## **ADDENDUM NO. 2**

Date: 8/7/26

Project Name: 9525.00 – IPBS Motivair Chiller Replacements

# MD101

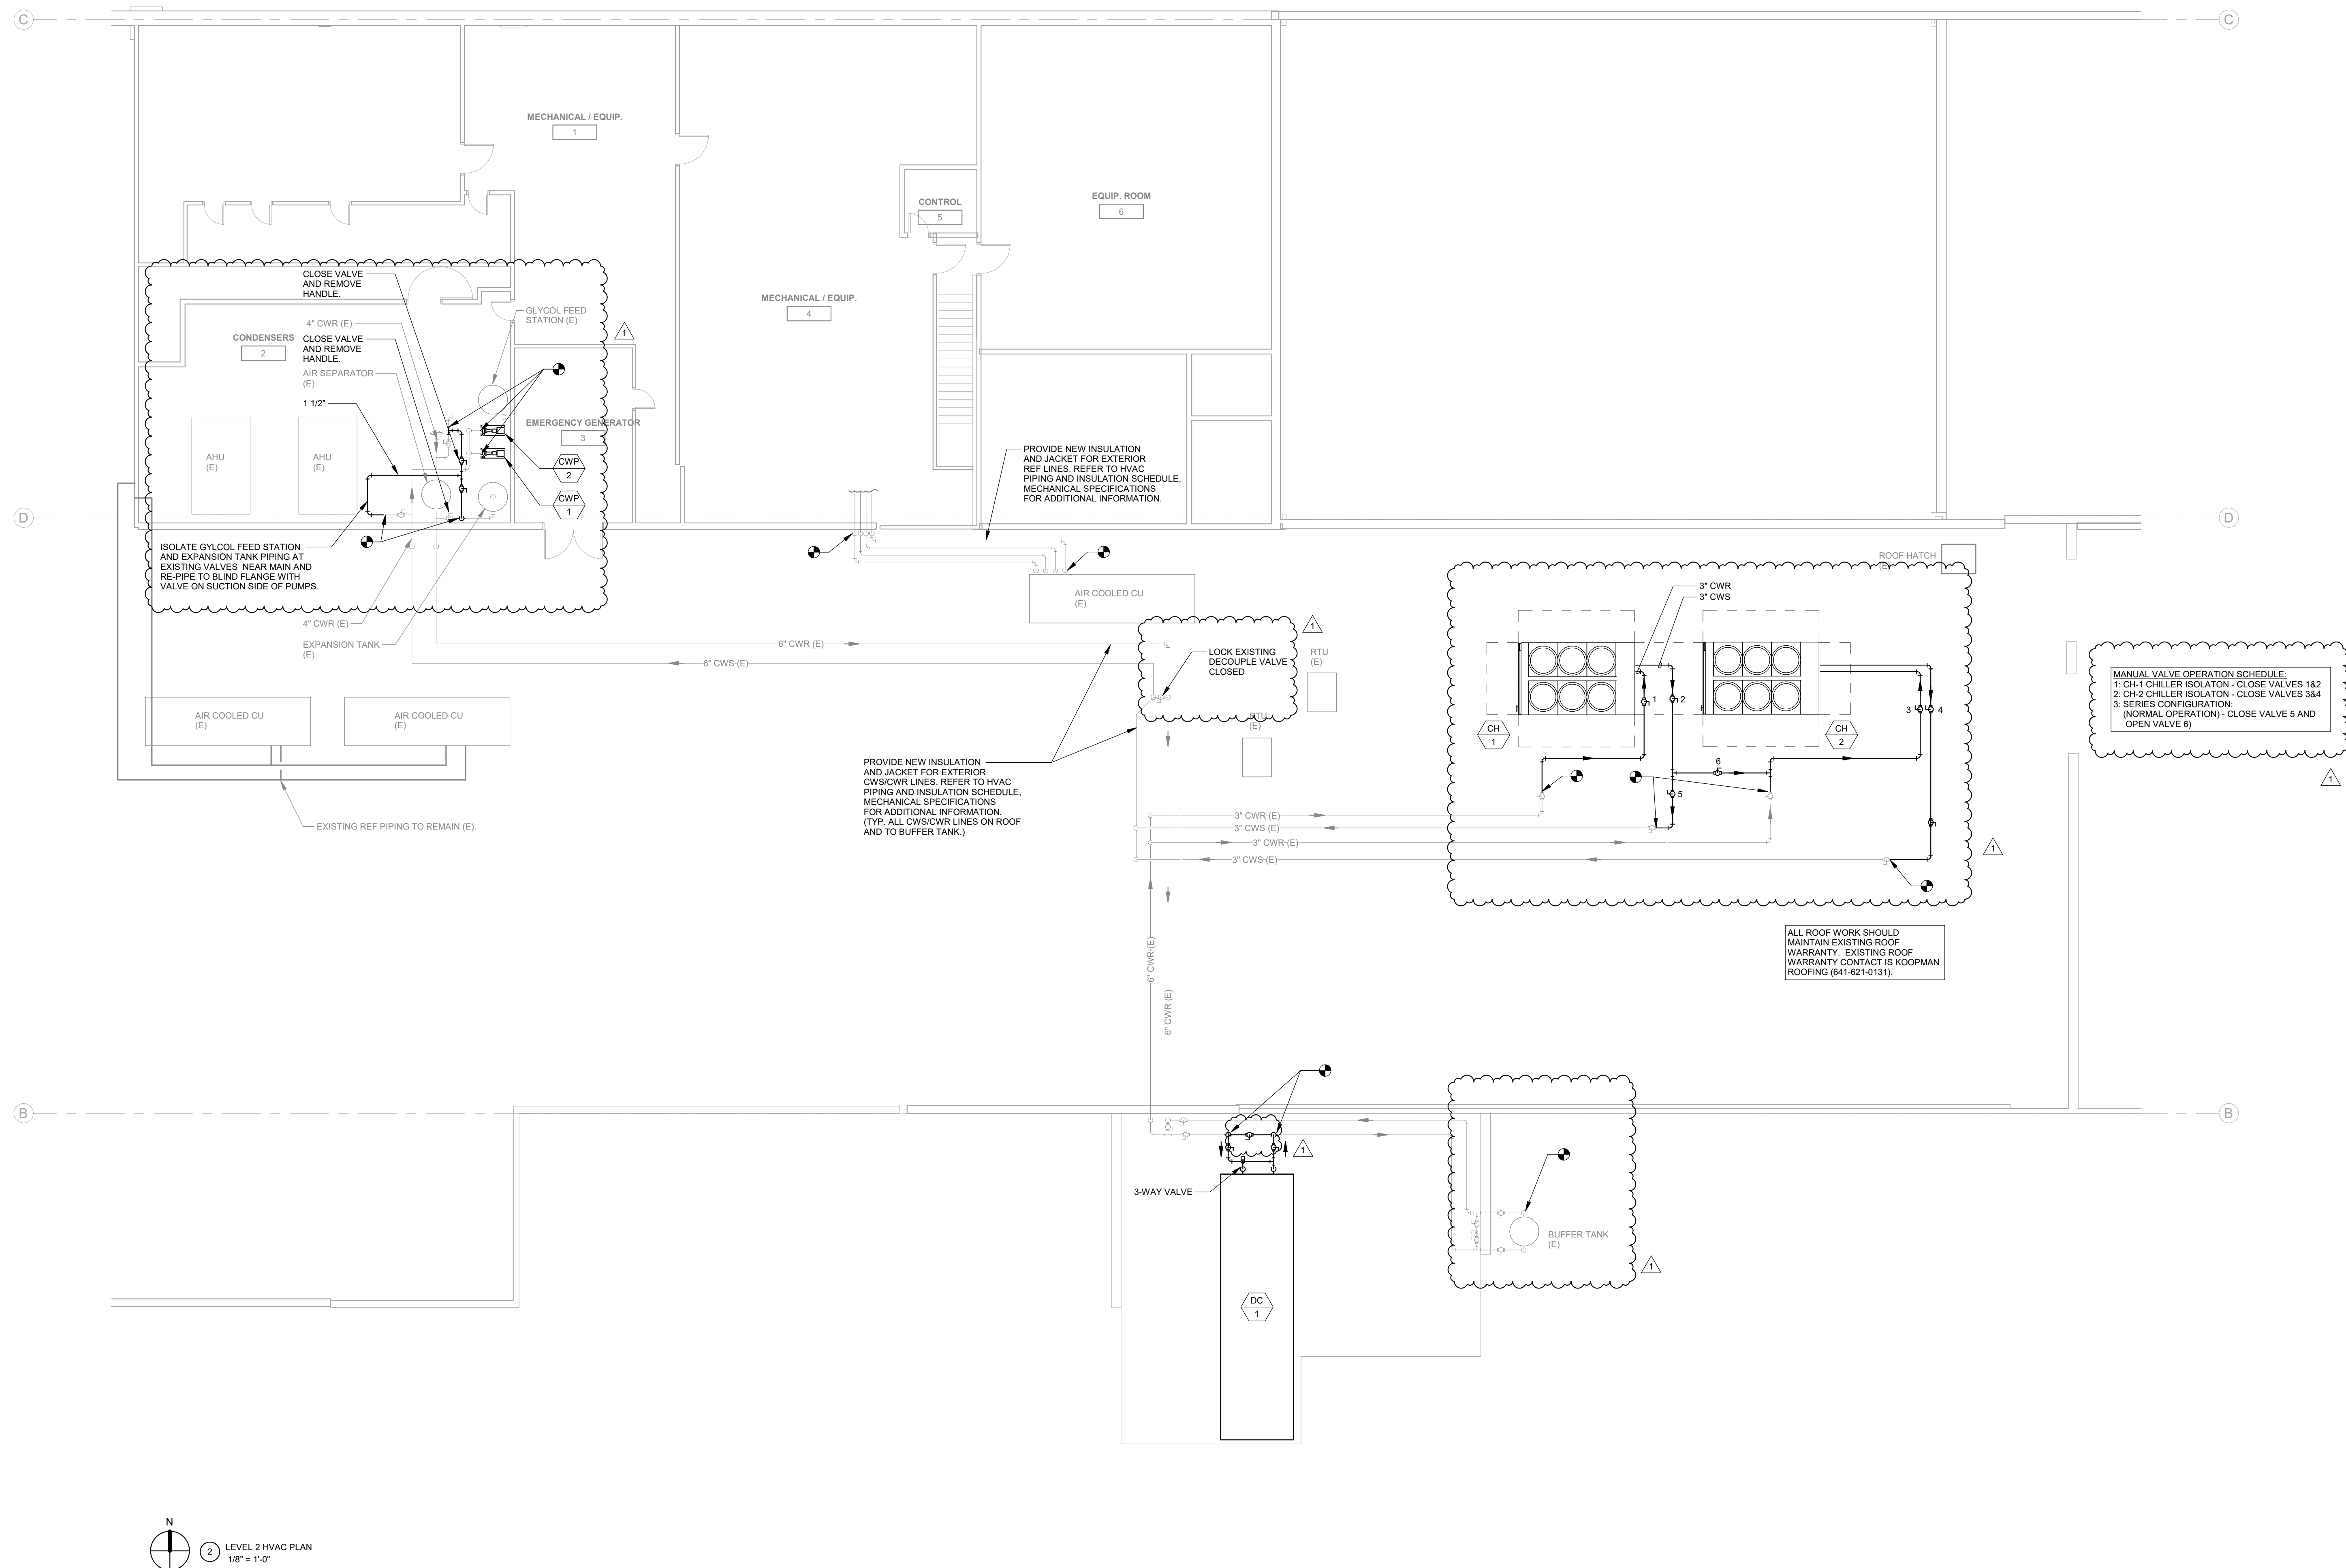
- 3) Drawing Updates:
  - a. Mechanical Drawings
    - i. Drawing MD101 – FLOOR PLAN HVAC DEMOLITION
      1. **MODIFY** chilled water piping as shown.
      2. **ADD** proposed chiller staging note as shown.

3. Refer to attached full size sheet MD101.
    - ii. Drawing M101 – FLOOR PLAN HVAC
      1. **MODIFY** chilled water piping as shown.
      2. Refer to attached full size sheet M101.
